Terex Utilities

SAFETY NOTICE

SN681A

SUBJECT: Leveling Sensor Installation

Figure 3A
This bulletin applies if the light colored potting visible on the top sensor, or sensor labeled A on the bottom

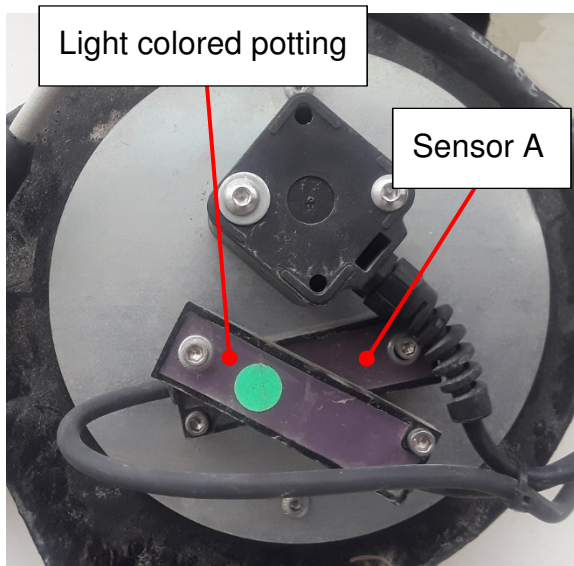
3. If your unit has the light colored potting visible on the top sensor, or the sensor labeled A on the bottom; this bulletin applies. Correct following the instructions in Field Service Kit Z1562. Take a picture before correcting the issue and another picture after correcting the issue. Send both pictures with the completion form including the serial number and date of correction to utilities.warranty@terex.com.
4. If your unit has the light colored potting visible only on the bottom sensor with the wires coming out of the sensors above the mounting screw and with sensor labeled A on top this bulletin does not apply and use can continue without restriction.

Figure 4B

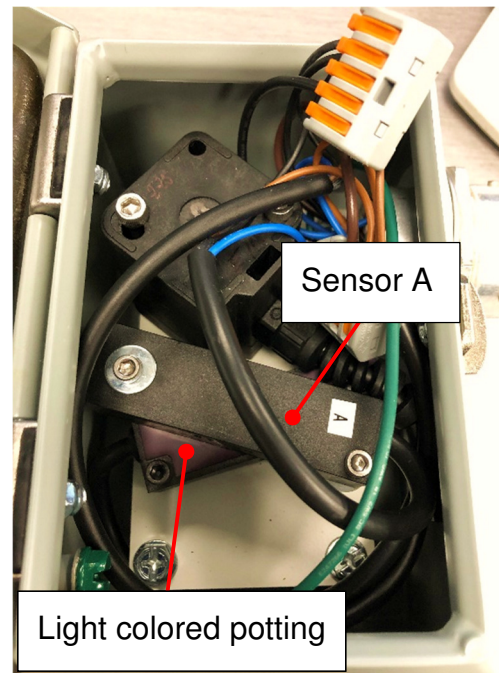
This bulletin applies if the light colored potting visible on the top sensor, or sensor labeled A on the bottom

This bulletin does **NOT** apply if the light colored potting only visible on bottom sensor and sensor labeled A on top
